**From:** Wiebe, Laura  
**Sent:** Tuesday, June 25, 2013 4:05 PM  
**To:** Luke Moger  
**Cc:** Ostritchenko, Dmitri  
**Subject:** Zone C crest width

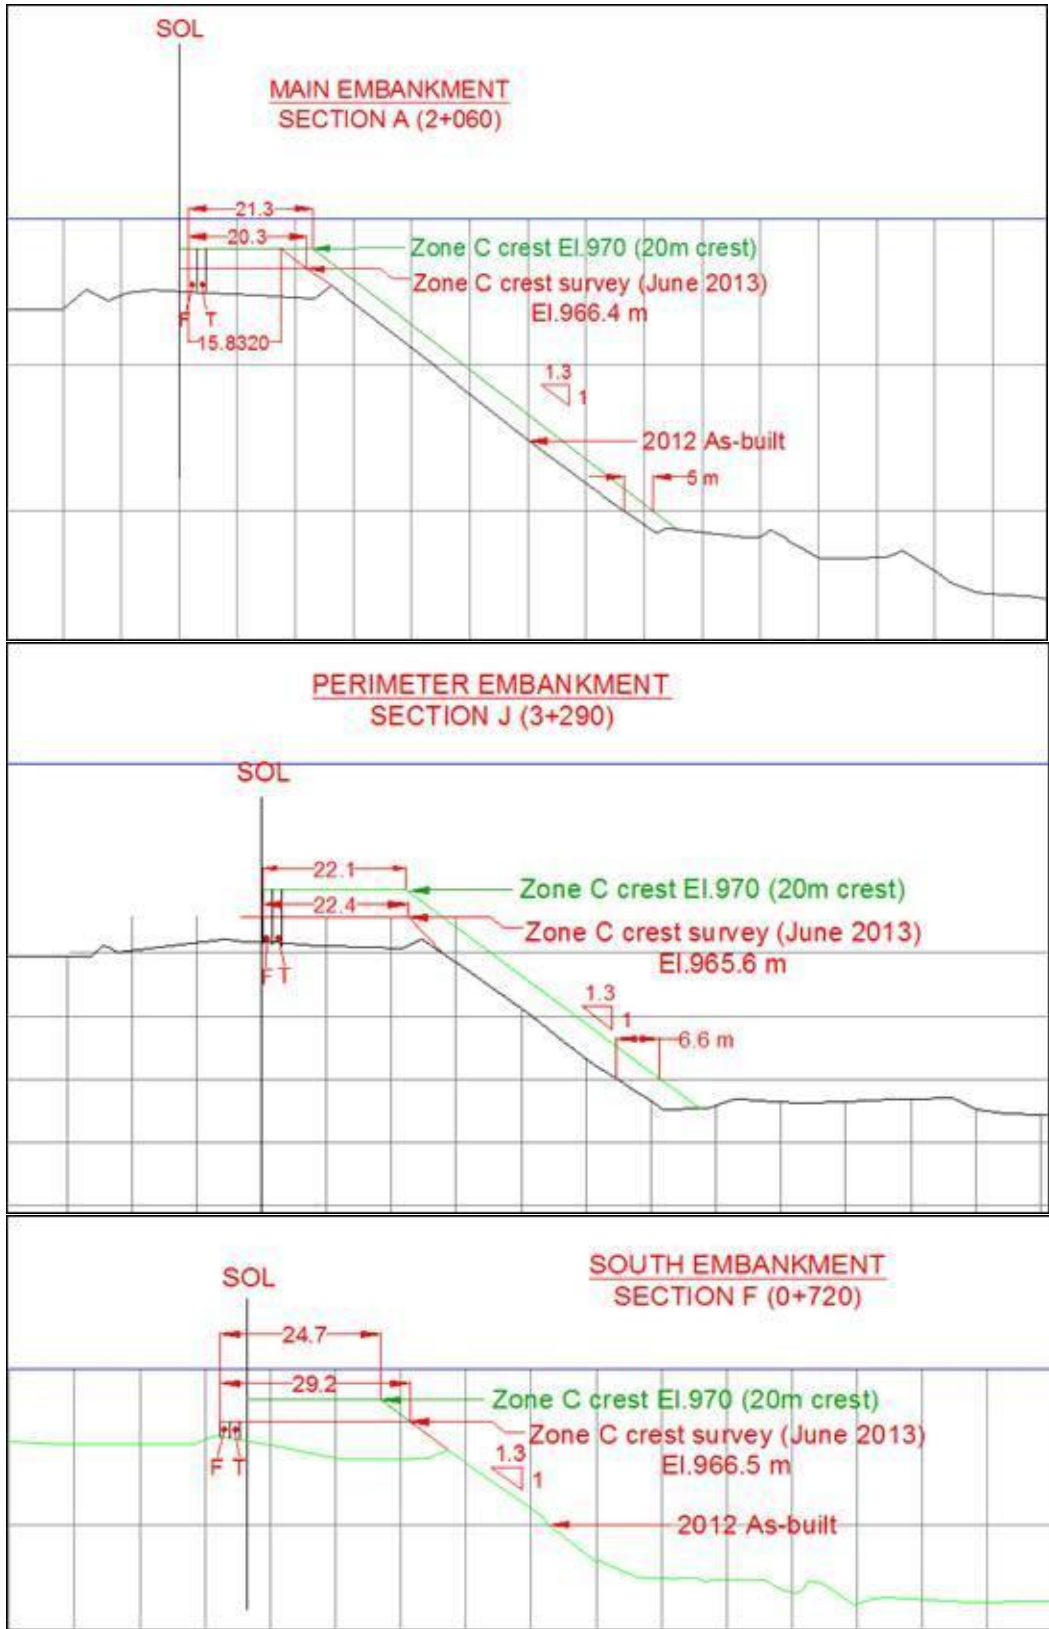
It seems as though the Main and Perimeter embankments would pose the most issues as far as driving width for equipment traffic. Any additional fill placed downstream of the current embankment (other than the main embankment buttress) would fall beyond the design scope of Stage 9 (El. 970m). However, additional rockfill placed downstream would typically increase dam stability rather than decrease it. So, there should be no issue with placing rockfill downstream to increase the crest width at 970m, as long as the downstream slopes remain consistent at 1.3:1 and foundation preparation specifications remain the same as those described in the Stage 9 construction monitoring manual.

To achieve a minimum crest width of approximately 20m, an additional 5m and 6.6m (horizontally) of Zone C would have to be placed downstream of the Main and Perimeter embankments, respectively. (see rough sketches below) The South embankment "as-is" appears to have no issue maintaining a minimum crest width of 20m at El. 970m.
